MCR Sportster F-PBCF

Electrical system

(12-00) April 9, 2025

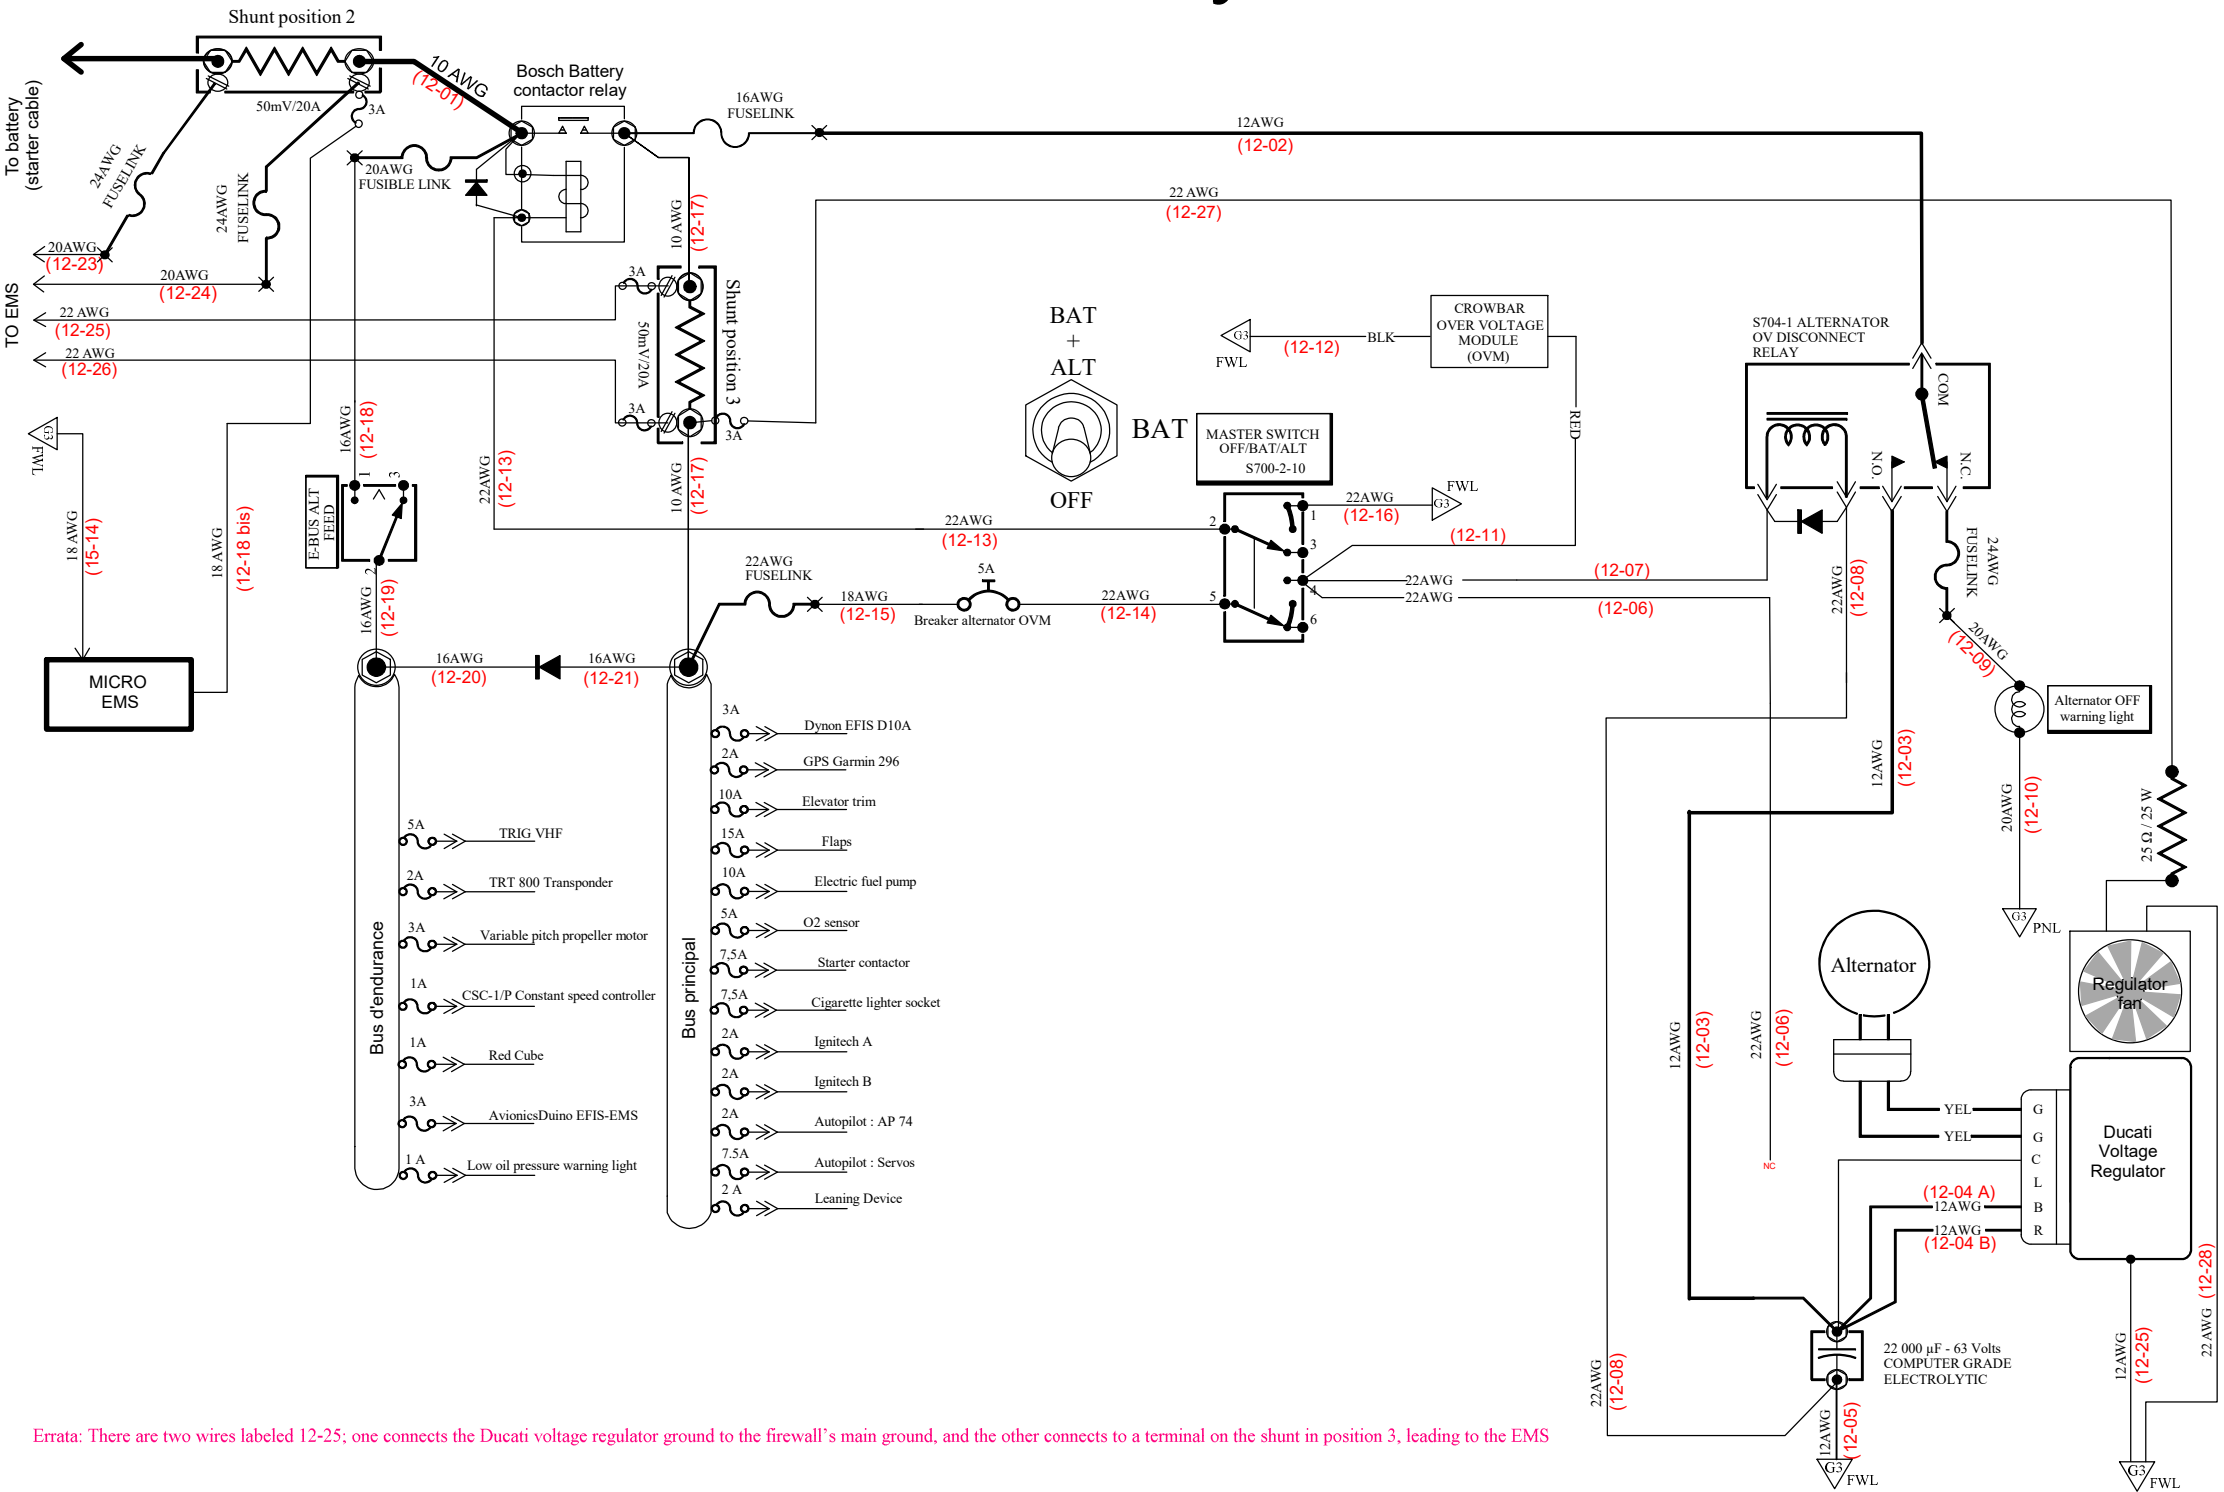
Errata: There are two wires labeled 12-25; one connects the Ducati voltage regulator ground to the firewall's main ground, and the other connects to a terminal on the shunt in position 3, leading to the EMS
